**(HCD 04/13)**

Proposed Express Terms – Revised 1 of 74 December 12, 2013  
 2013 CBC (Title 24, Part 2, Ch. 11A “Housing Accessibility”) – 2013 Intervening Code Adoption Cycle  
 Housing and Community Development (HCD)

FIGURE 11A-6B  
HANDRAILS

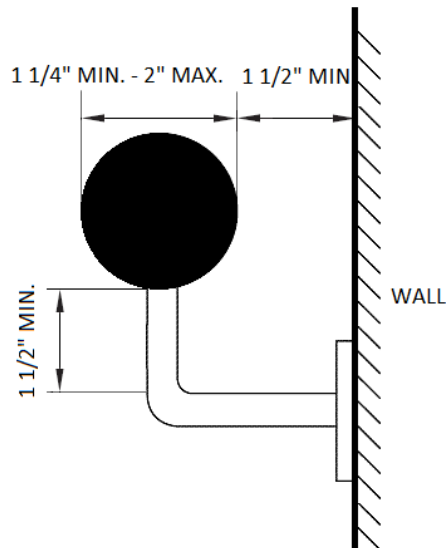
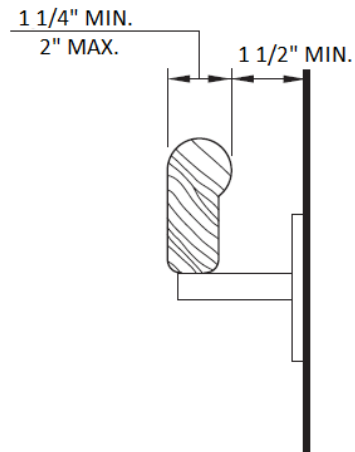
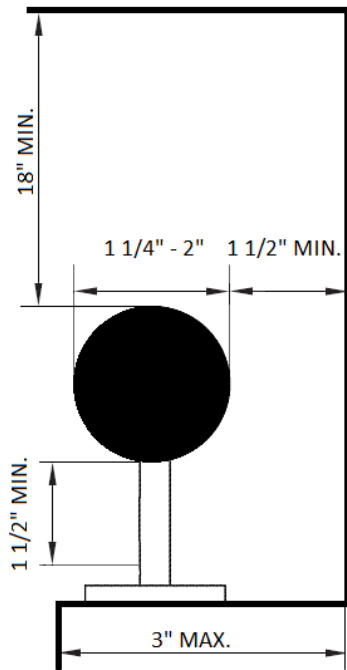
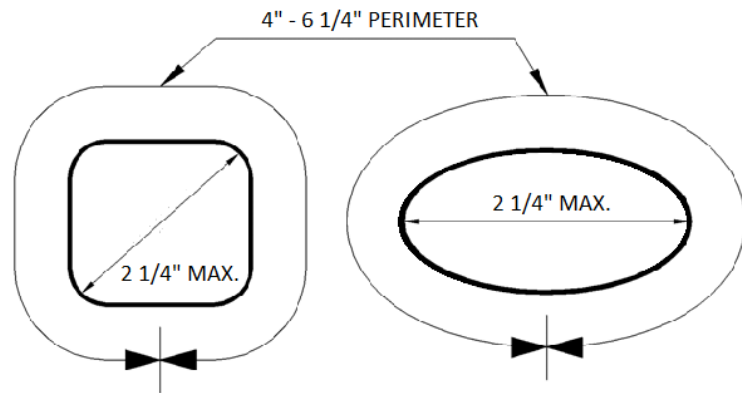
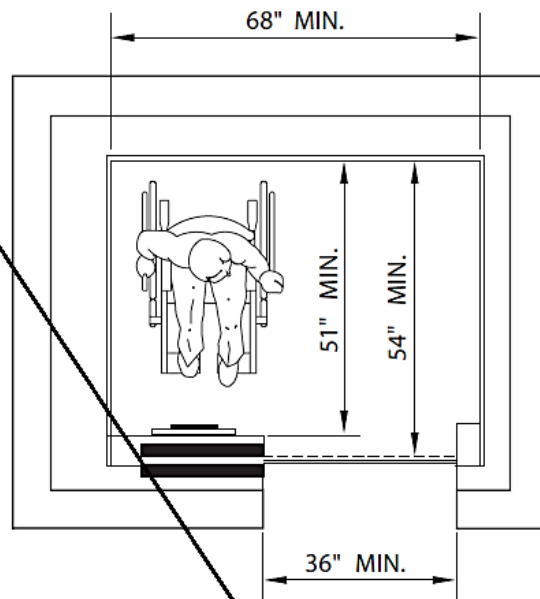
**1114A.6.2.5 Handrail grips.** ~~The handgrip portion of handrails shall not be less than 1¼ inches (31.75 mm) nor more than 2 inches (50.8 mm) in cross-sectional dimension or the shape shall provide an equivalent gripping surface. The handgrip portion of handrails shall have a smooth surface with no sharp corners. Edges shall have a minimum radius of 1/8 inch (3.17 mm). Handrails shall not rotate within their fittings. (See Figure 11A-6B).~~

**1114A.6.2.6 Cross section.** *Handrail gripping surfaces shall comply with this section, or the shape shall provide equivalent gripping surface.*
